DEPARTMENT OF TRANSPORTATION

Federal Aviation Administration

[Docket No. FAA-2022-1647; Project Identifier AD-2022-01379-T; Amendment 39-22438; AD 2023-10-02]

Airworthiness Directives; Transport and Commuter Category Airplanes

Figure 1 to paragraph (g)(1)(i)— *Fundamental Effective Isotropic PSD at Outside Interface of Airplane Antenna*

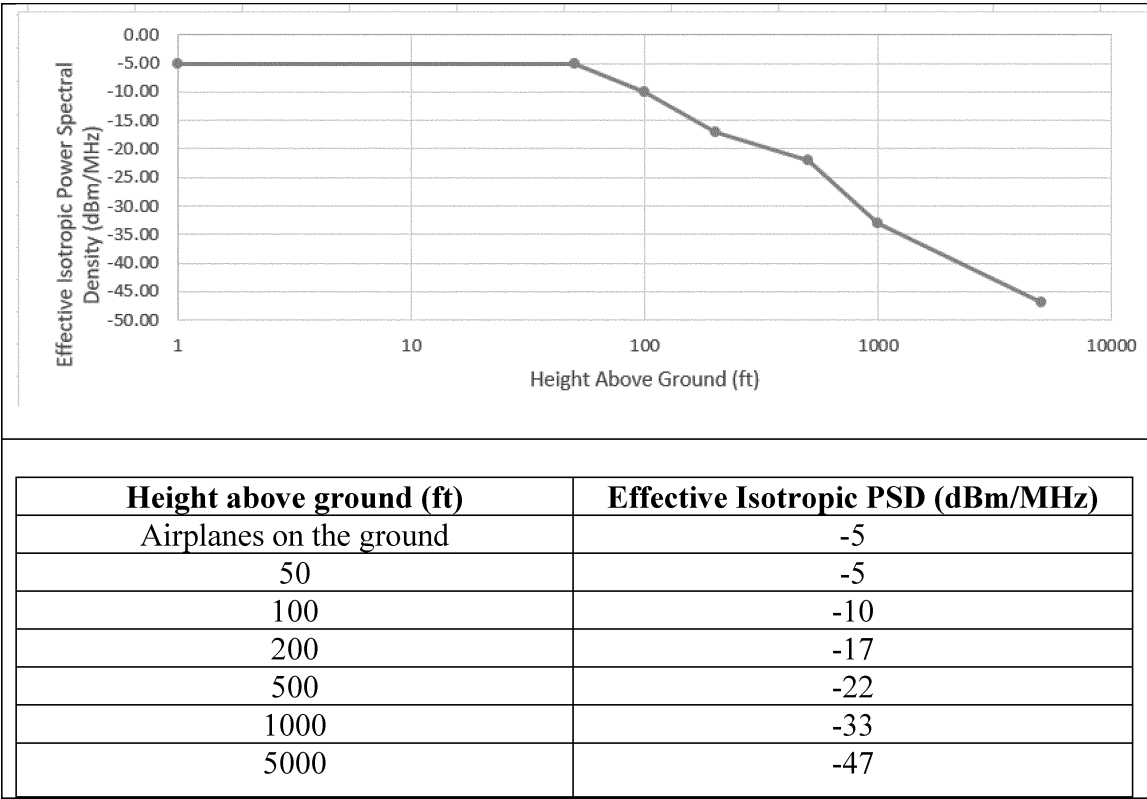
Comment summary: Textron Aviation requested the FAA clarify at what reference point the PSD requirements apply. The commenter stated it assumed that they apply at the radio altimeter receive antenna input, such that antenna characteristics, coax loss, and filter characteristics would be included in the determination.

FAA response: The FAA agrees and has changed the title of figure 1 to paragraph (g)(1)(i) of this AD to reflect that the PSD requirements apply at the antenna input to the radio altimeter, and that the figure applies to the outward facing side of the antenna.

Figure 2 to paragraph (g)(1)(ii)— *Spurious Effective Isotropic PSD at Outside Interface of Airplane Antenna*

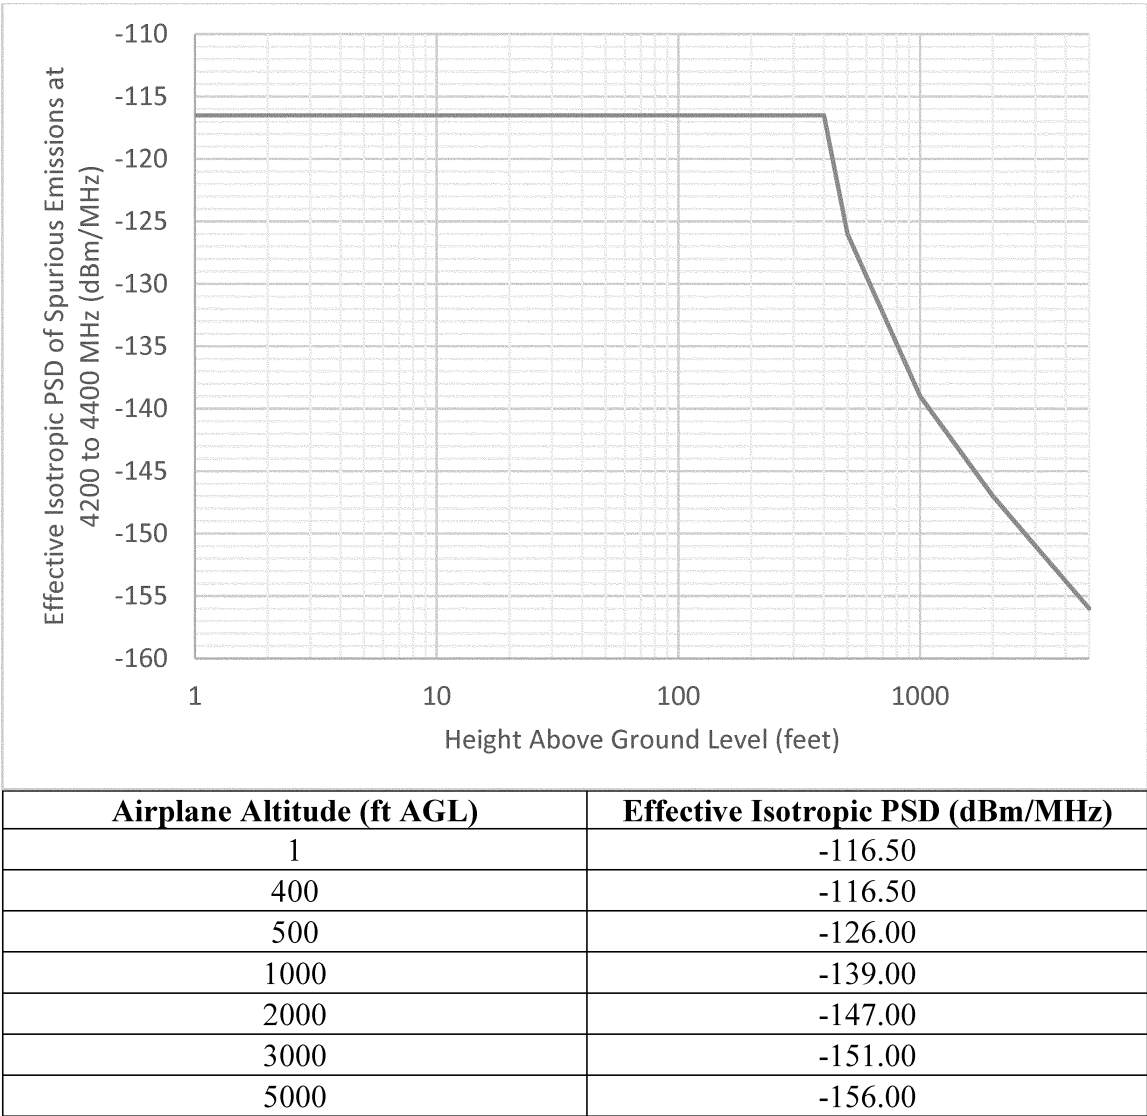
Comment summary: AIA requested that the FAA provide more information about the tolerances for determination of whether an airplane is radio altimeter tolerant. Several commenters requested that the FAA add a new figure indicating the spurious tolerance, similar to the figure with the PSD tolerance curve, and a specification of the altitude dependence for spurious tolerance.

FAA response: The FAA agrees and has replaced the proposed fixed emission level with a spurious PSD tolerance curve in figure 2 to paragraph (g)(1)(ii) of this AD. Subsequent figures have been redesignated accordingly.
